Housing Delivery Authority – Major Projects 300 Burns Bay Road Lane Cove (SSD- 87925706)

Attention Gabriel Kim,
Department of Planning, Housing and Infrastructure

Thank you for the opportunity for Lane Cove Council to comment on the redevelopment and rezoning proposal for the site at 300 Burns Bay Road.

Figure 4A: Height proposed Rezoning Map. (Source: Colliers)

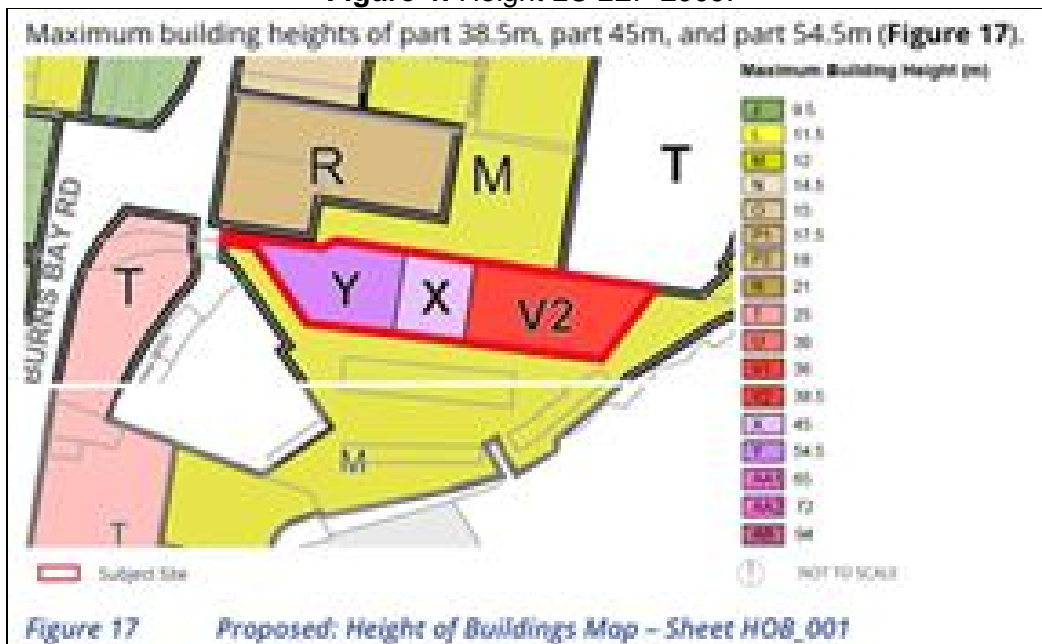
The proposed development seeks to additional height beyond the 30% bonus height afforded by the SEPP as shown in the table below. Council does not support any variation to the 30% bonus. It is noted that the Height has further increased since Council provided PRE-DA comments in September

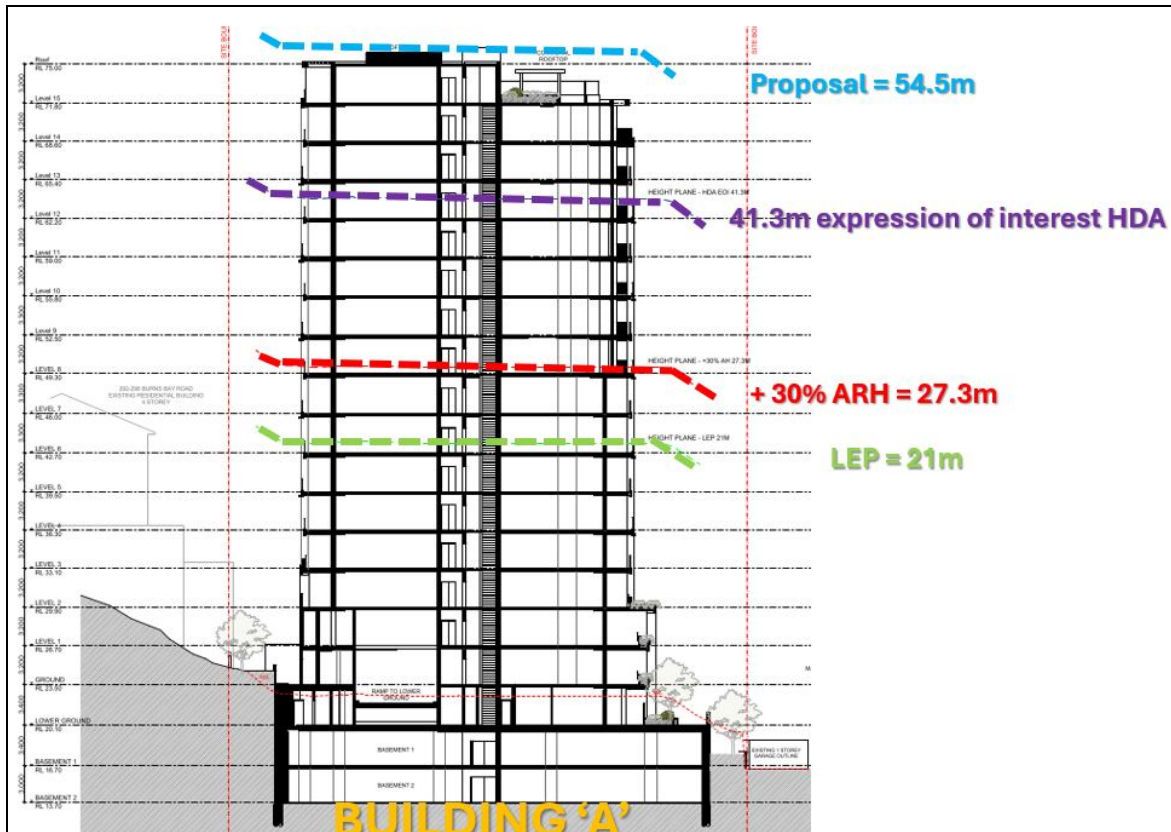
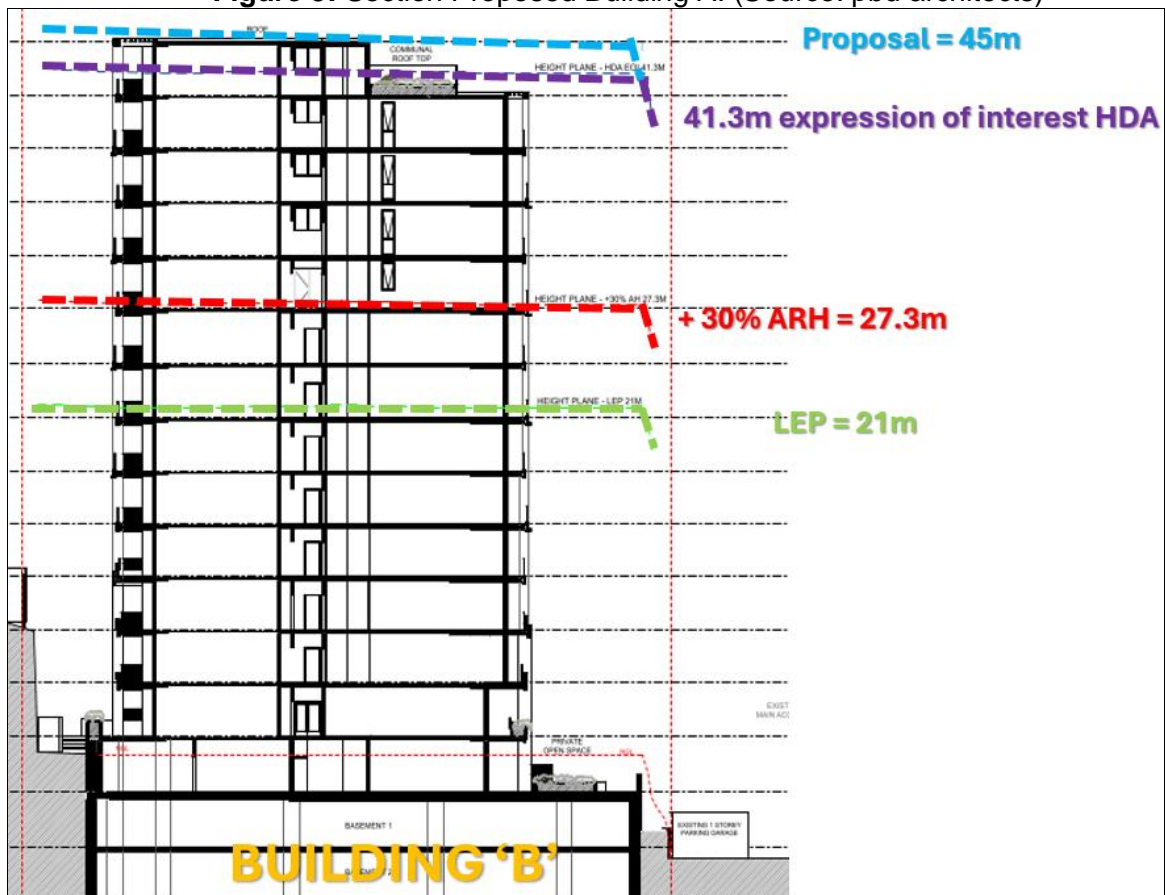
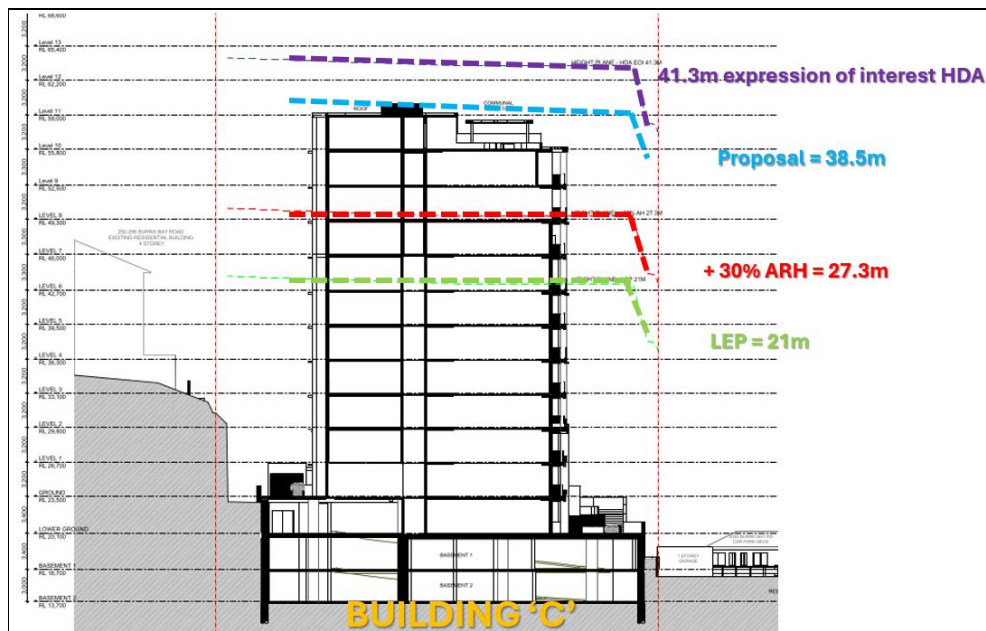
The proposed development fails to satisfy the relevant objectives of Clause 4.3 Height of the Lane Cove LEP 2009:

The non-compliant portions of the building result in additional adverse overshadowing impacts on the properties to the south of the site. Any additional shadowing generated by the non-compliant area of the development is considered unreasonable, unnecessary and not warranted in this instance. The rezoning request in relation to height should not be supported as the proposal fails to satisfy objective (a).

The non-compliant portions of the building would be visually prominent to the adjoining properties, which has been identified in the view impact assessment document. The non-compliant areas which result in these adverse impacts to the most sensitive receivers being the residential developments downslope of the site. The non-compliant setbacks to the north of the site result in adverse privacy and overlooking impacts. The Rezoning request should not be supported as the proposal fails to satisfy objective (b).

The proposed height increase has not taken into consideration the existing topographic constraints of the site. The steep topography and orientation of the site exacerbate overshadowing and any additional building height and bulk is required to be sensitively designed to minimise these impacts. The proposed building height fails to step down appropriately with the topography of the slope. The proposed buildings have not been appropriately setback from the southern boundary to minimize overshadowing impacts. The Rezoning request should not be supported as the proposal fails to satisfy objective (d).

Figure 8A: FSR proposed Rezoning Map. (Source: Colliers)

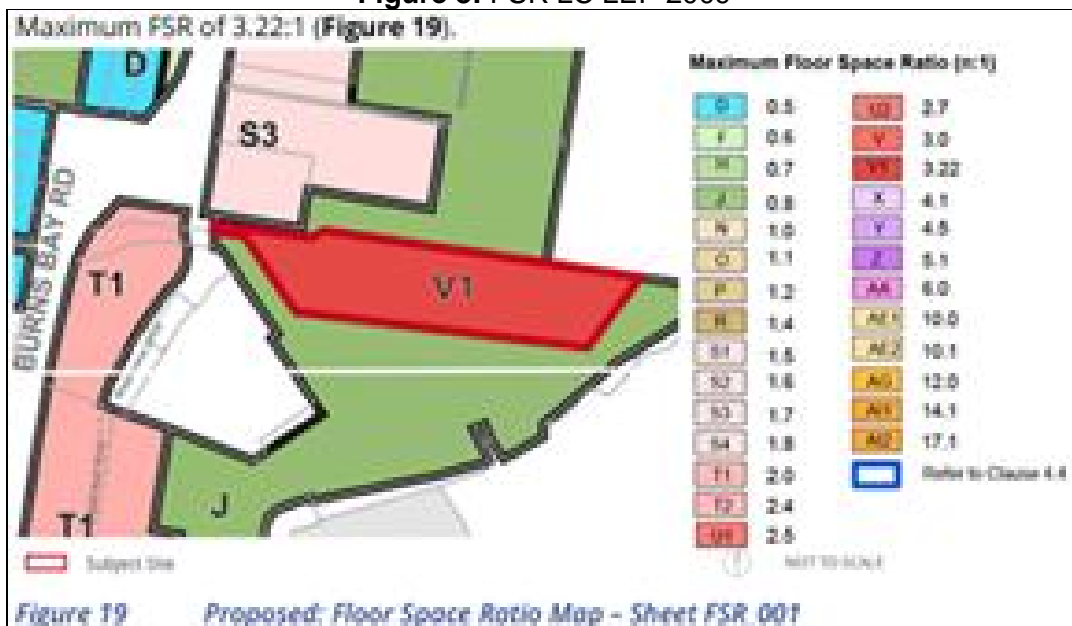
The proposal would result in a significant increase in the FSR proposed beyond the 30% bonus afforded by the SEPP. Council does not support any variation above the 30% bonus. It is noted that the FSR has further increased since Council provided PRE-DA comments in September 2025. Previously at 3.13:1 or 23,758sqm. A further 673sqm of GFA has been added (to 3.22:1) further exacerbating the FSR breach to approximately 65% above the controls.

The proposed FSR is not compatible with the established character of the locality, including existing 8-storey residential and mixed-use buildings on Waterview Drive. Approval of the density as a spot Re-zoning, would set a detrimental precedent for other rezoning in the proximity. The accumulated impacts are overly negative in an undesirable location which cannot accommodate adequate infrastructure to accommodate the increased population.

Figure 9: Excerpt of Level 7 Plan. Non-compliant building separation of Building B. (Source: pbd architects)

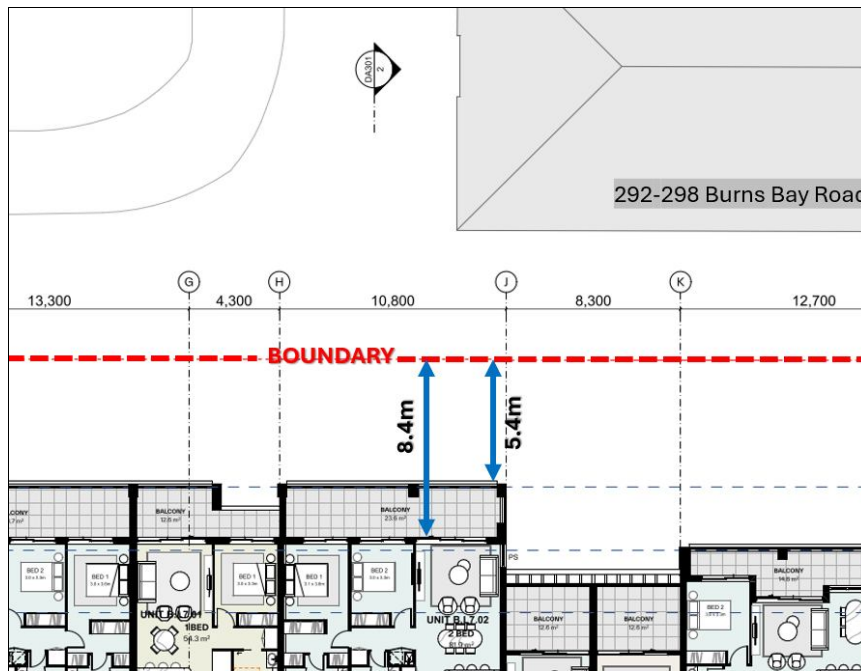
The proposed setback for the north elevation of tower B does not comply. Including the northern balconies being setback approximately 5.6m, and glass line of the internal spaces being setback approximately 8.4m. (Refer to figures 9 and 9A below). The lack of building separation would result in adverse privacy/overlooking impacts between the south-facing units of 292-298 Burns Bay Road and north-facing units of the subject site.

Comment: The proposal fails to comply with Section 3F Building Separation in the ADG.

Figure 9B Ground floor units facing retaining wall.

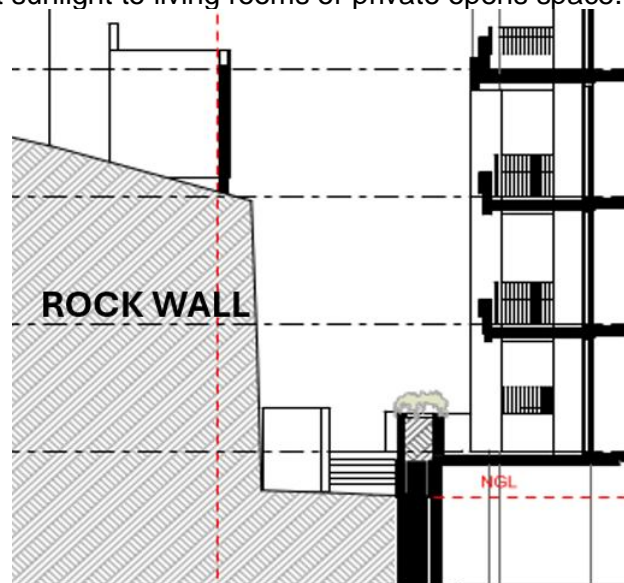
Many of the north-facing ground and first floor units are not considered to achieve adequate amenity. These units face onto a sheer 7.4m high retaining wall. The retaining wall is approximately 4.8m distance away from the units and blocks access to sunlight. The below table details the 5 dwellings most negatively affected.

As noted in the solar access section below. These units contribute to the overall non-compliant total (19%) number of dwellings which receive zero solar access at mid-winter. The proposal also includes a large number of dwellings which are exclusively south-facing and receive no direct sunlight to living rooms or private opens space.

Comment: The proposal fails to comply with Section 4L GF Apartments in the ADG.

Figure 19: Proposed Deep Soil Diagram Darker green overlay is required 10m bushland buffer.
(Source: pbd architects)

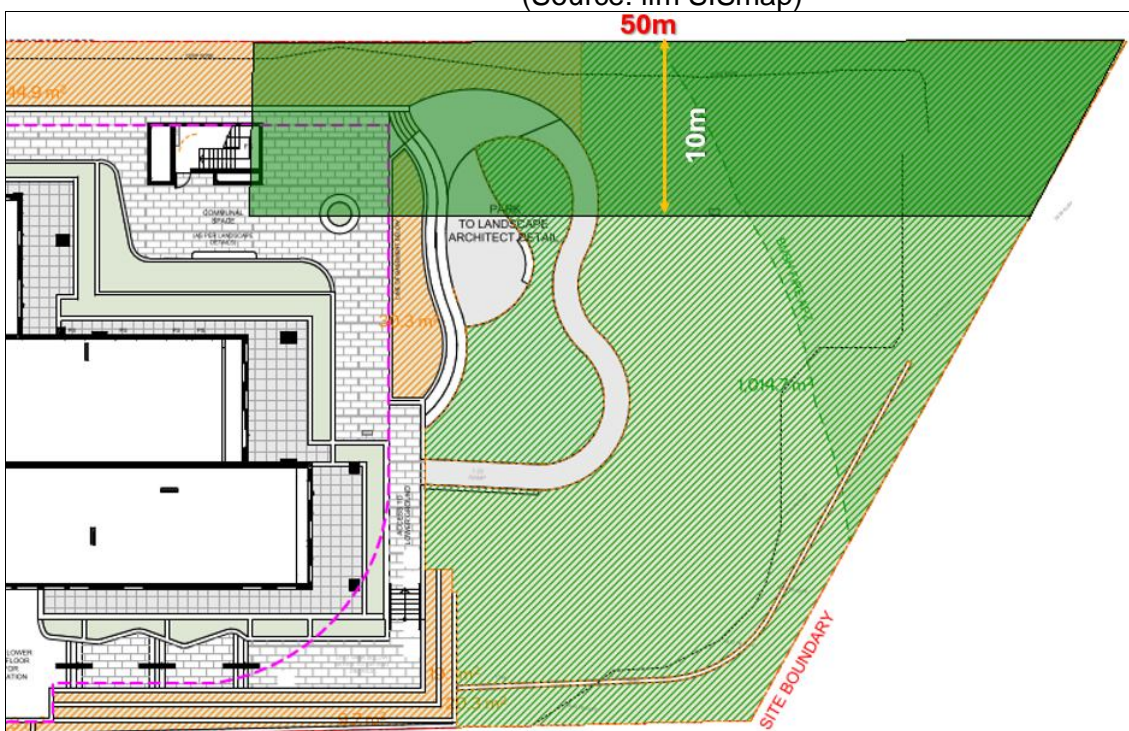
Council's Part H Bushland Protection stipulates a 10m bushland vegetation buffer is required to be applied to boundaries adjacent to bushland for adequate bushland protection.

recommends that the design is amended to comply with the 10m bushland buffer.

Figure 20: Stormwater Concept Design: (Source S & G Consultants)

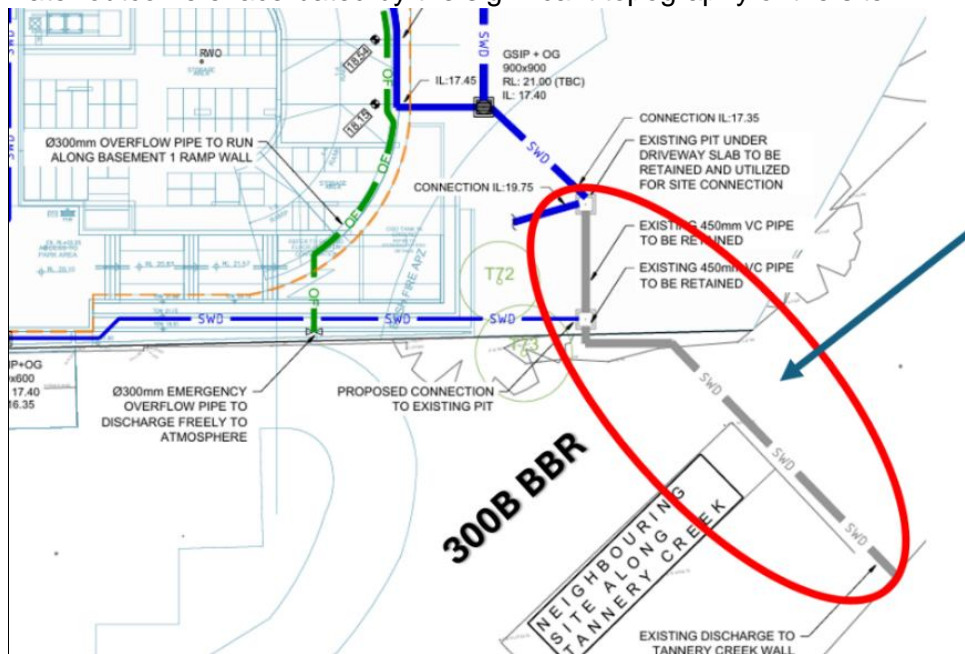
The stormwater concept design by S & G Consultants Sheet 07 makes reference to propose to connect the new stormwater line to an existing pit under driveway and existing 450mm VC pipe running through 300B Burns Bay Road and discharging to the Tannery Creek Wall. (Refer to Figure 20). It is noted that the submitted survey by Exceed Consulting Group (Sheet 06 of 15) makes no reference to this pipe system. (Refer to Figure 21). The DP 1230609 on Page 19 of the EIS makes

- The application has failed to provide any written owners' consent permitting the proposed stormwater to connect to the pipe at 300B Burns Bay Road;
- A New Positive Covenant has not been provided for future maintenance of the connection to the pipe and pit;

- A CCTV report of the existing condition of the pipe at 300 BBR has not been provided. This report is essential as it is required to confirm if the stormwater connection can adequately accommodate the large additional water flow; and

- The new development will obstruct the existing overland flow path from upstream at 292-298 Burns Bay Road. For this reason, the development would need to provide a new separate Pit and Pipe system at the northern side of the site to capture upstream overland flow and direct accordingly. This has not been provided, resulting in an adverse and unacceptable stormwater outcome exacerbated by the significant topography of the site.
